ENGINEERING CERTIFICATION REPORT

Cell 5-AB

Re: OWL NDBL SWMF Cell 5-AB Construction Plans
Document Received 4/24/2023

CONSTRUCTION PLANS

LANDFILL
SUBGRADE
GRADING
PLAN

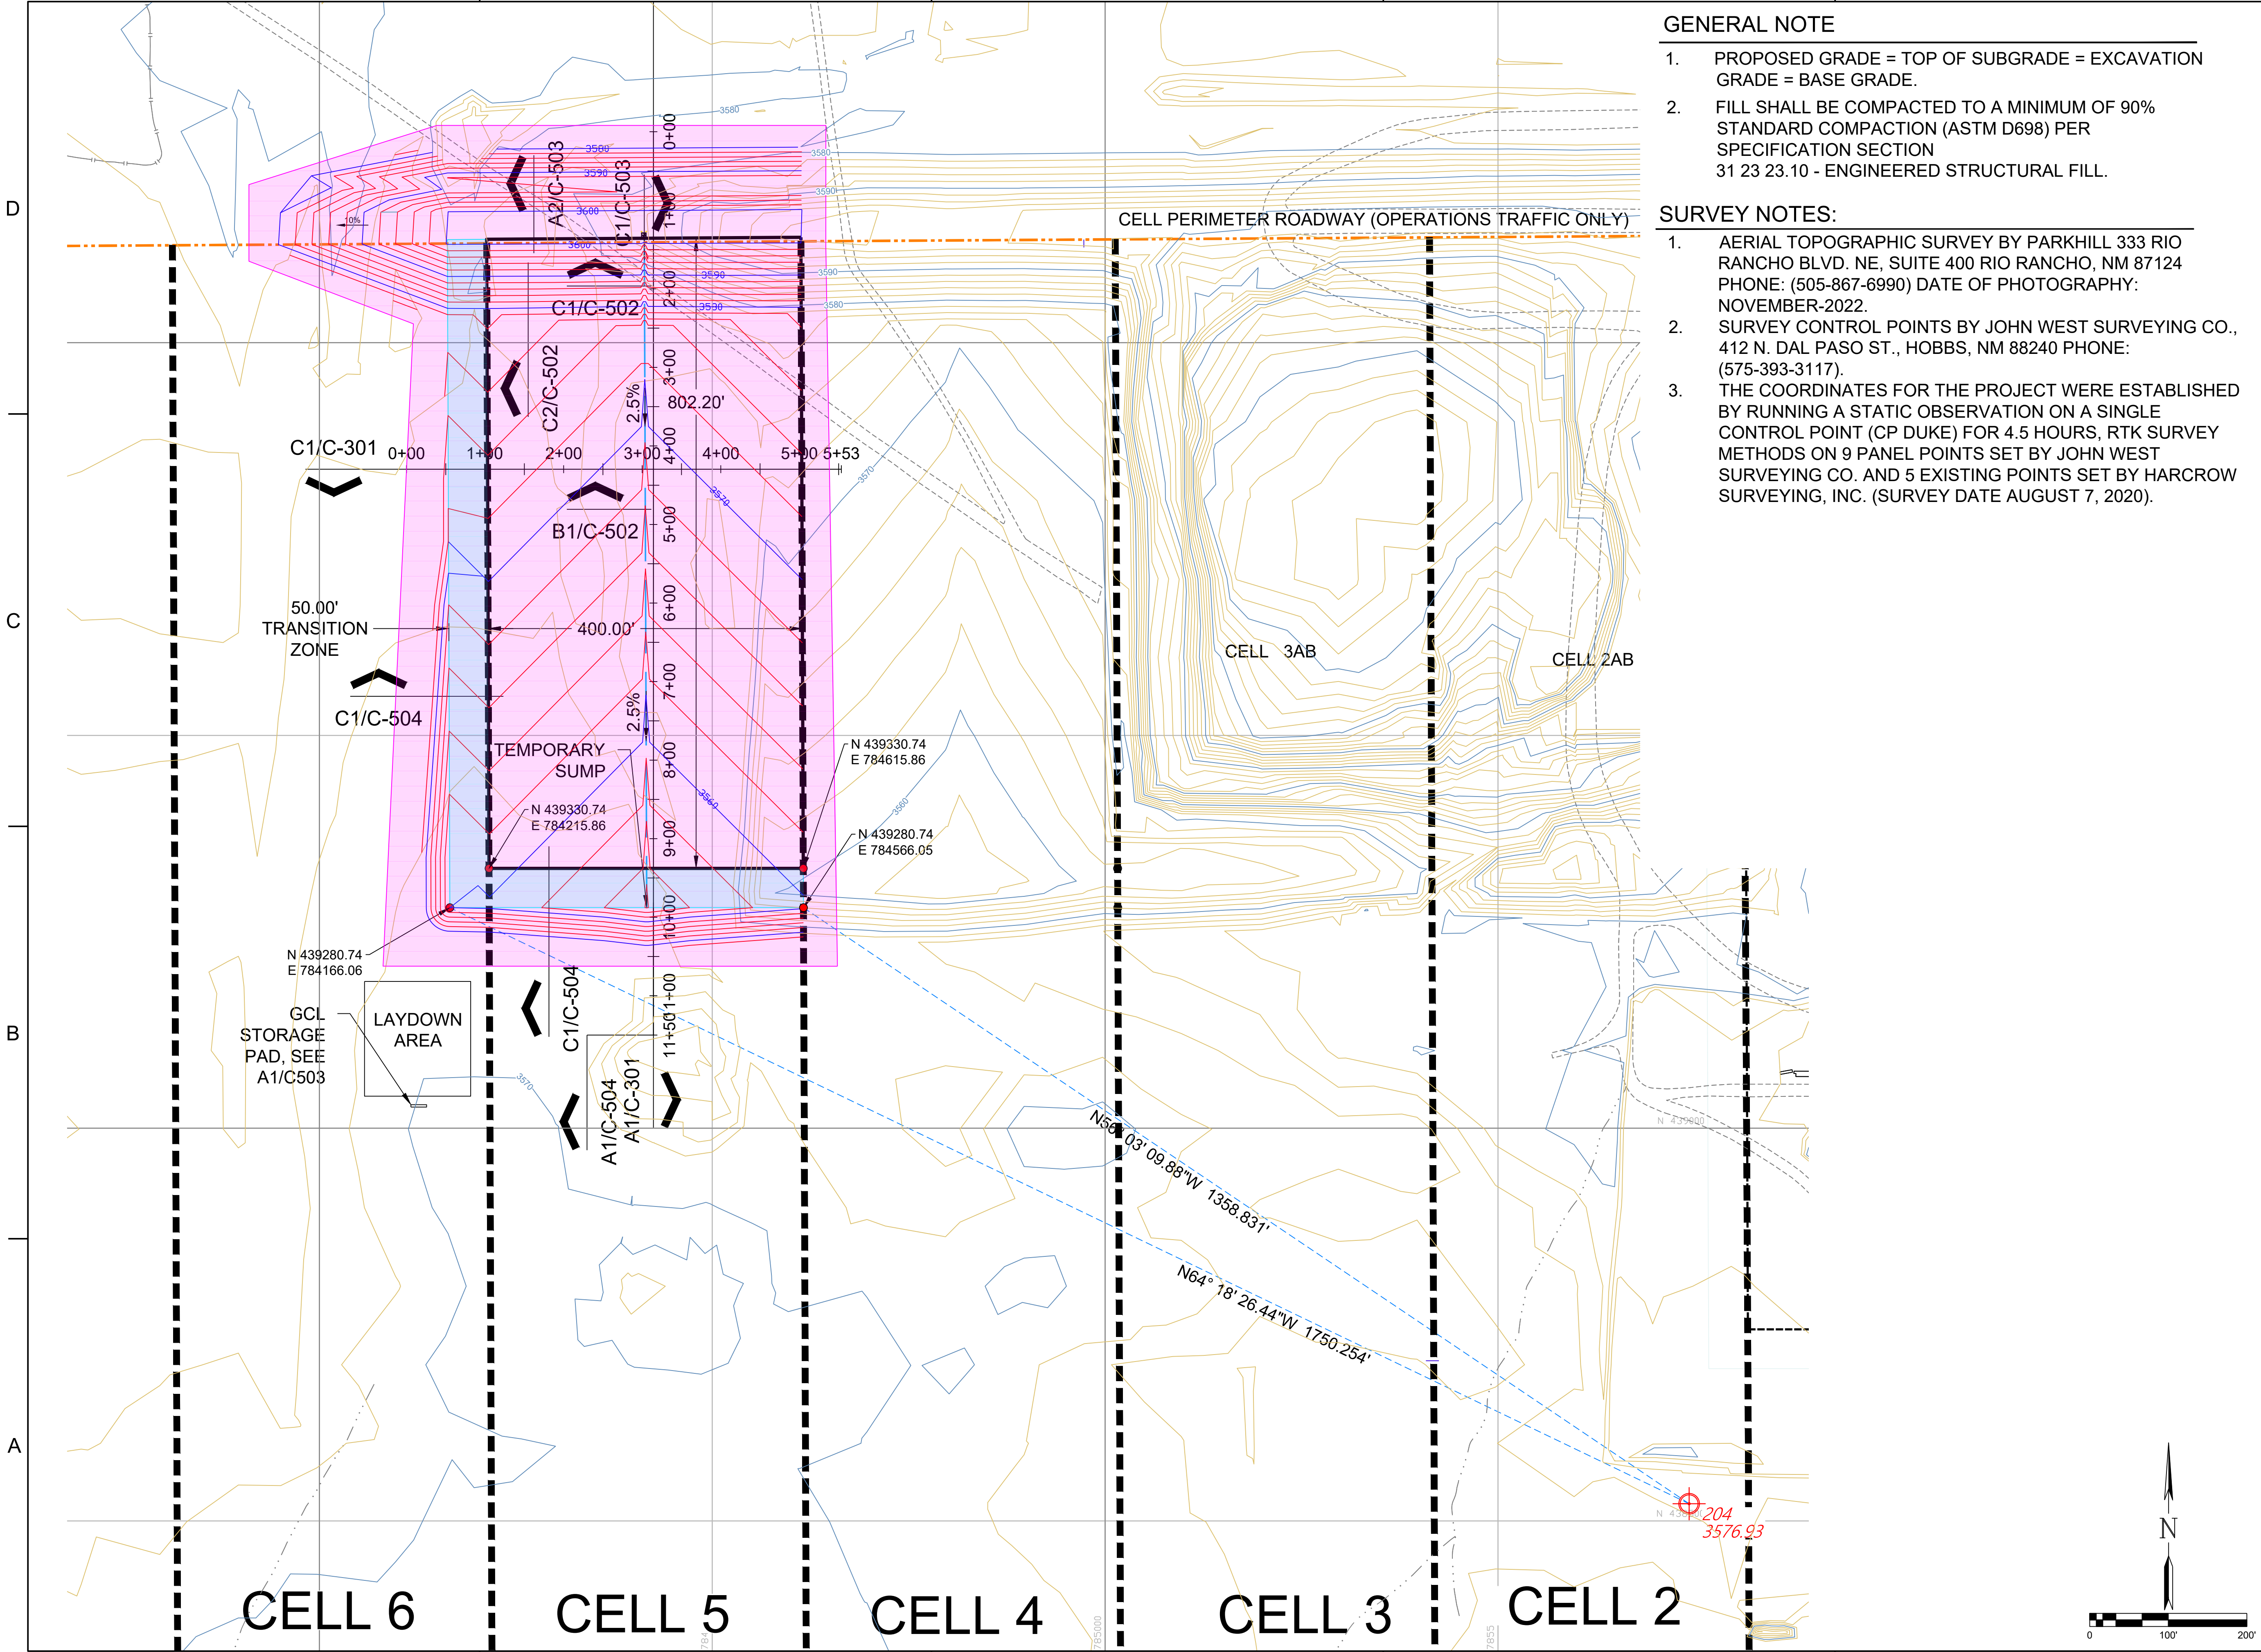
As stated the multi-layered liner system for cell bottom and sideslope is the same as approved for Cells 3-AB and 4-AB. An inside cell slope of 4H:1V is provided at the northern portion of the Cell 5-AB with an outside slope of 3H:1V. A general note indicates a specified compaction density for this fill construction at 90% standard proctor dry density

C-104

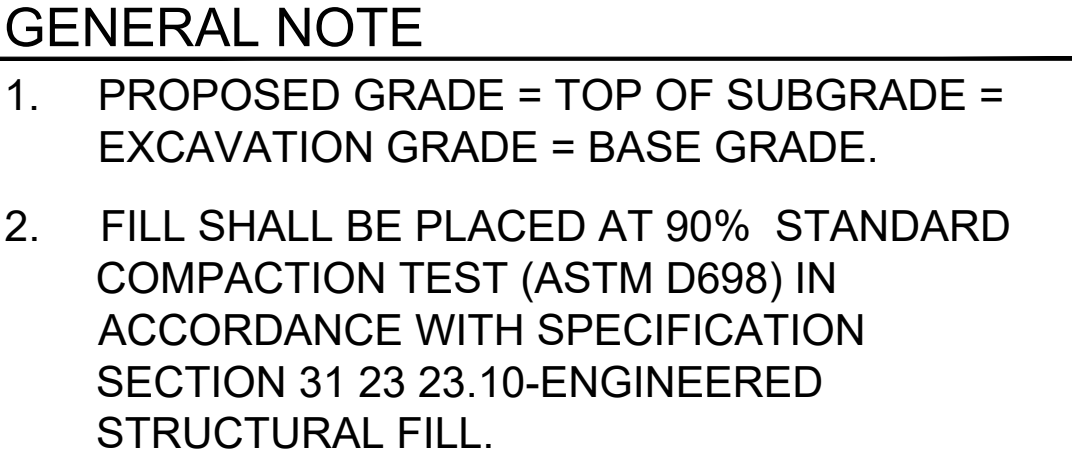
(ASTM D698). The anchor trench constructed at the top of the berm fill also specifies a 90% standard proctor dry density. No cut-fill estimates based on the cut-fill tic plan (Sheet C-104) were provided as was done for Cell 4-AB; however, based on the north-south cross-section existing topography and proposed in-ground cell layout, it is my professional opinion that a net soil volume balance would be available, more than sufficient to construct the northern berm. L-shaped liner anchorage is typical per industry standard and compliant with regulatory requirements. The specified bottom cross-slope on the subgrade grading plan for Cell 5-AB provides a 2.5% minimum liner slope. Compaction for the subgrade and is specified at 90 % standard proctor dry density.

B2 PERFORATED LEACHATE COLLECTION PIPE
NOT TO SCALE SECTION VIEW

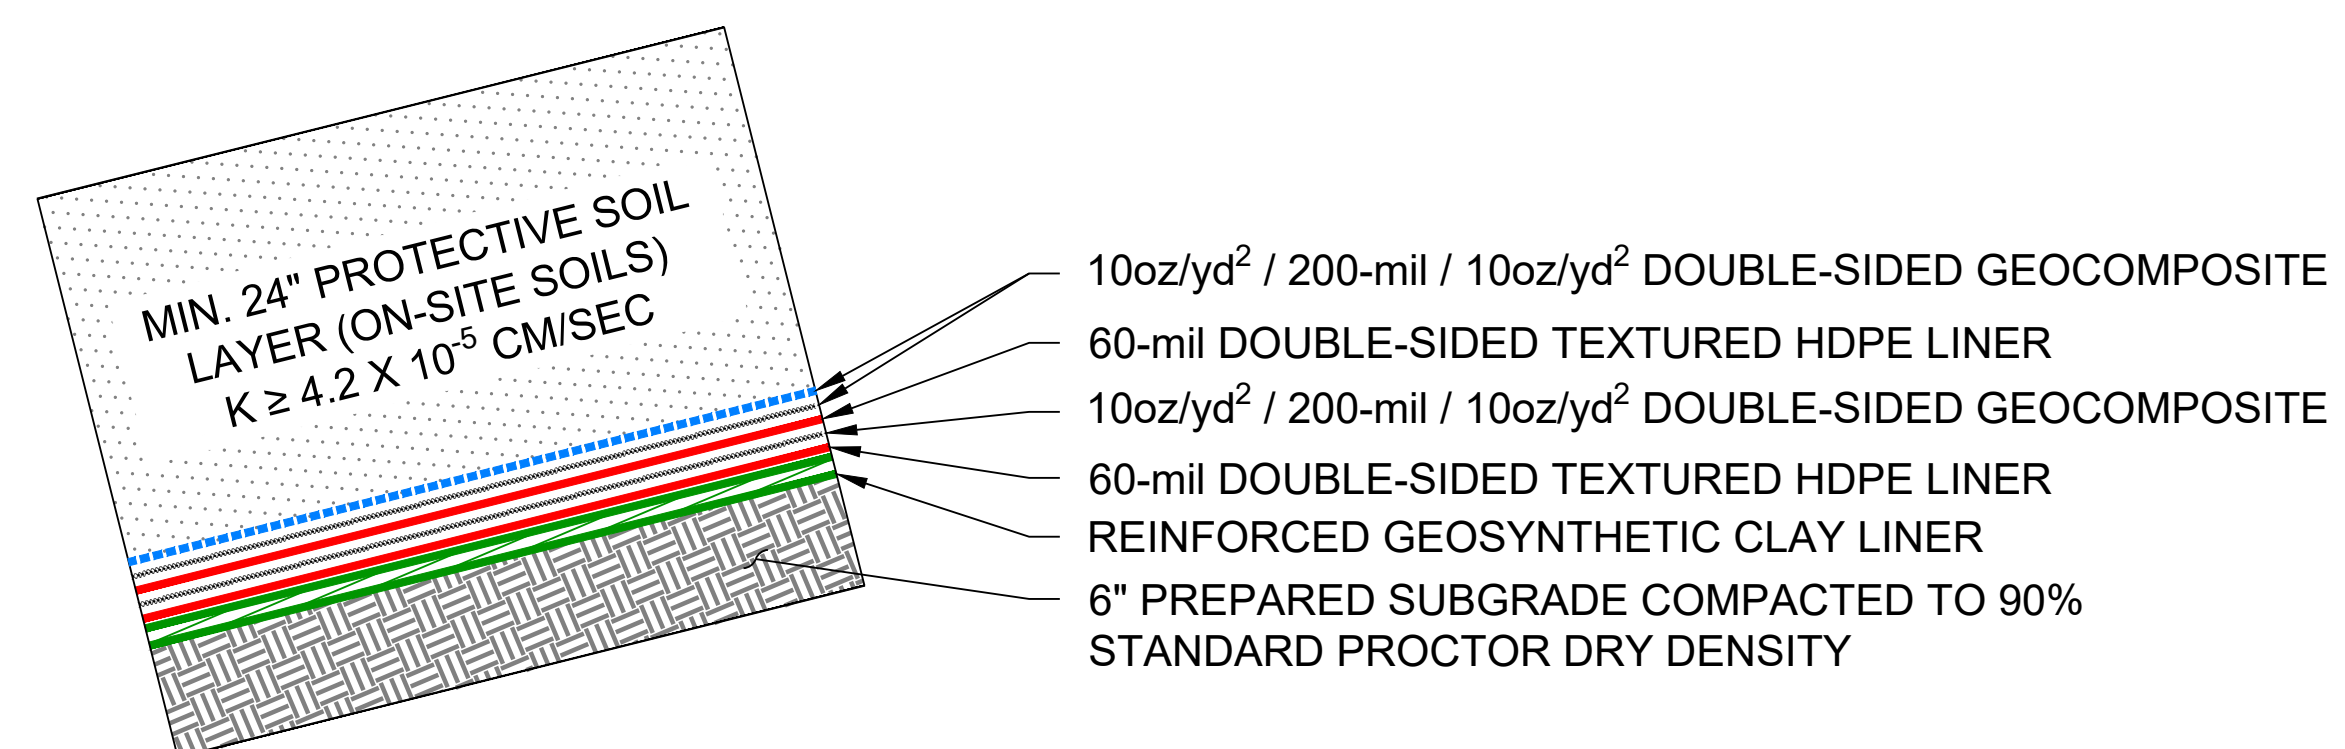
The leachate collection trench at 2.5 % exceeds the minimum prescriptive slope requirement of 2 %. Leachate collection trench and piping as well as cleanout riser and trench are typical per industry standard and are compliant with prescriptive regulatory requirements. A 2 ft protective soil layer over the double composite liner system meets the prescriptive depth requirement. A saturated hydraulic conductivity of greater than or equal to 4.2×10^{-5} exceeds the prescriptive requirement.

C1 TYPICAL CELL TRANSITION AREA
NOT TO SCALE SECTION VIEW

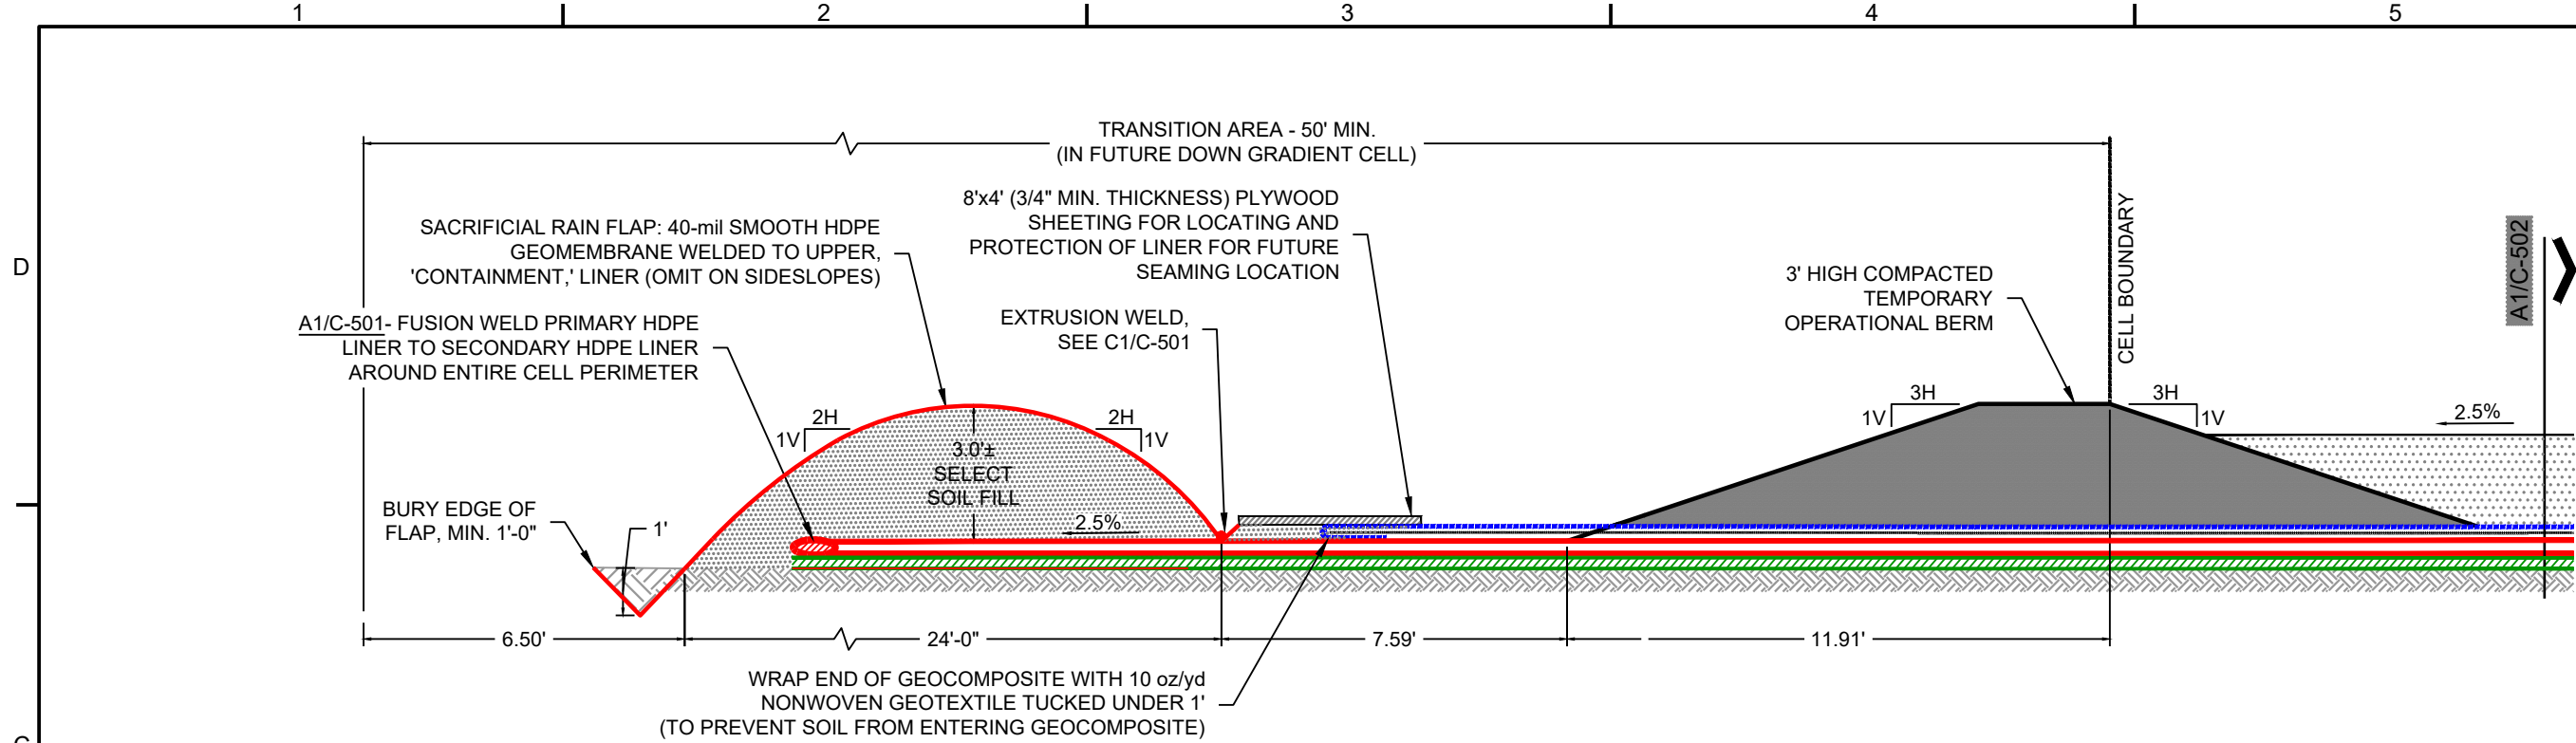
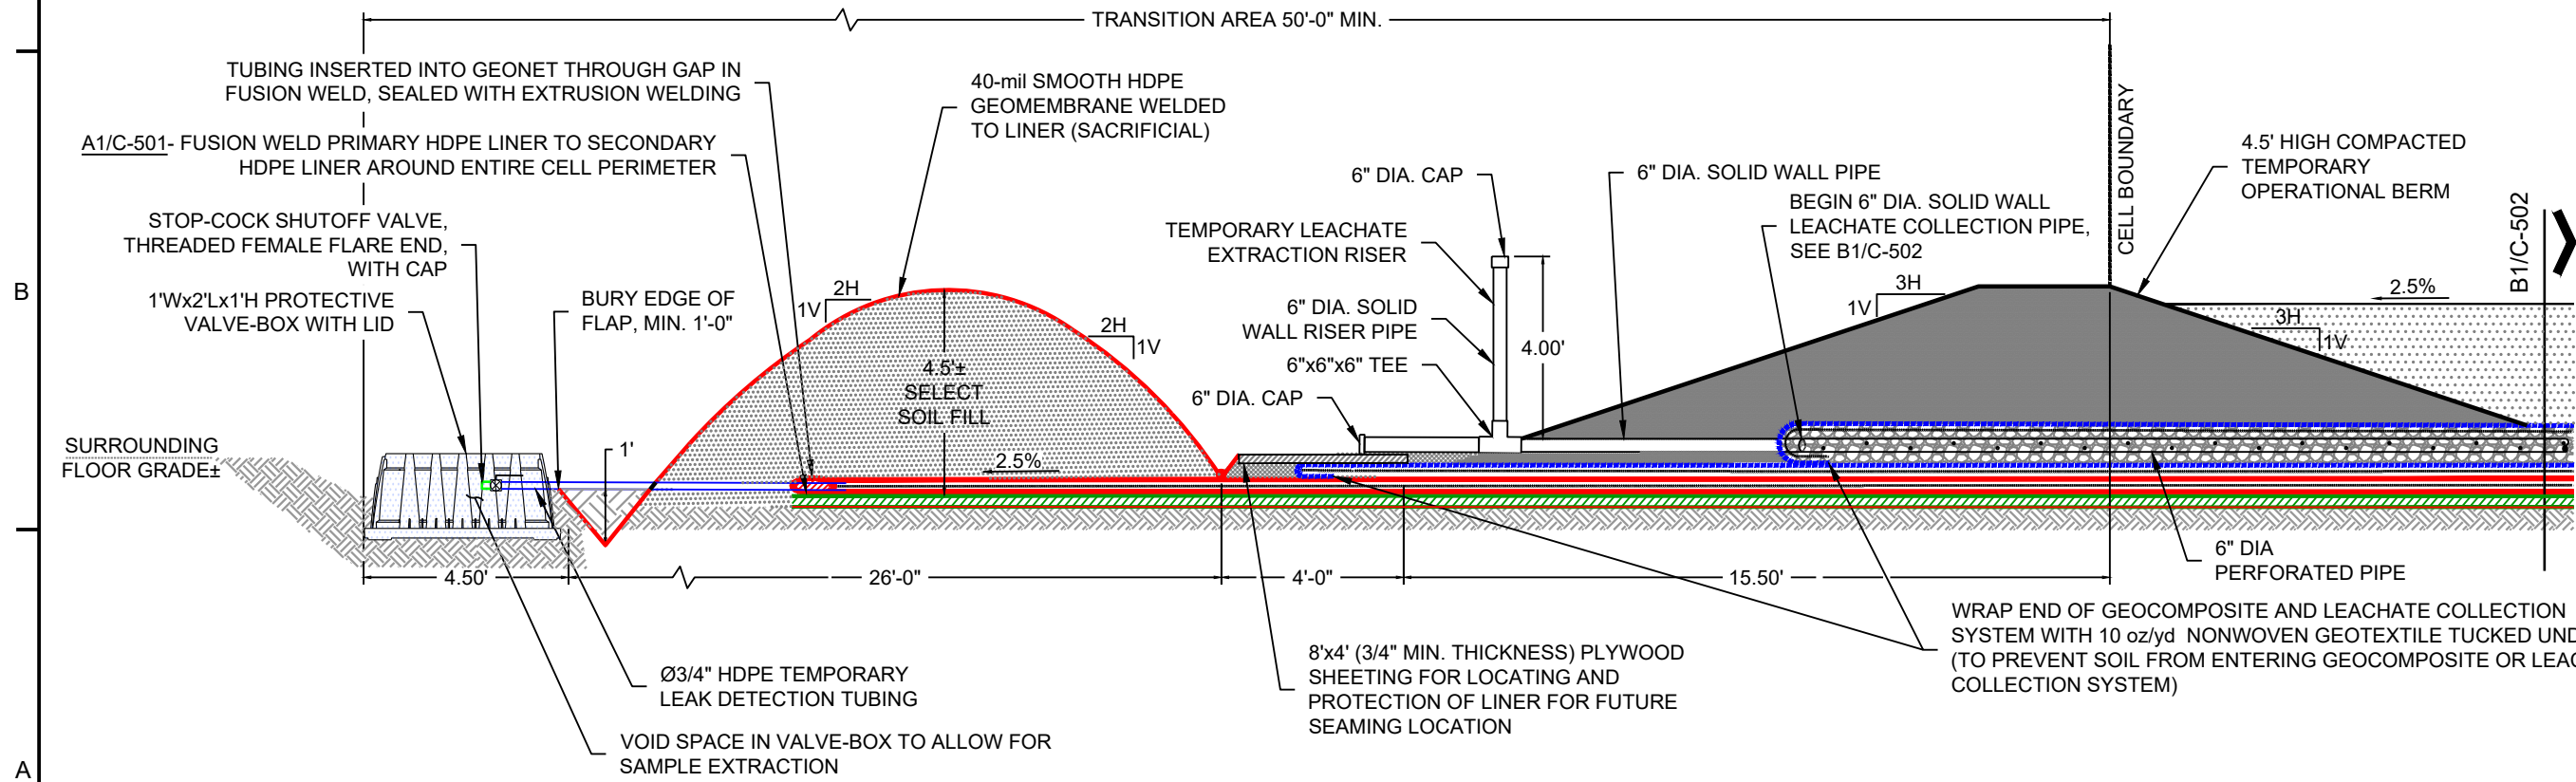
Cell transition details for Cell 5-AB to the west and south at the lower portion of Cell 5-AB are typical per industry standard and are compliant with prescriptive regulatory requirements. A temporary sump for leachate extraction and leak detection was provided at the south end of Cell 5-AB for tie-in downgradient. These details are typical per industry standard and are compliant with prescriptive regulatory requirements. Easy access to leachate extraction and monitoring of leakage through the primary barrier layer is facilitated with the design provided.
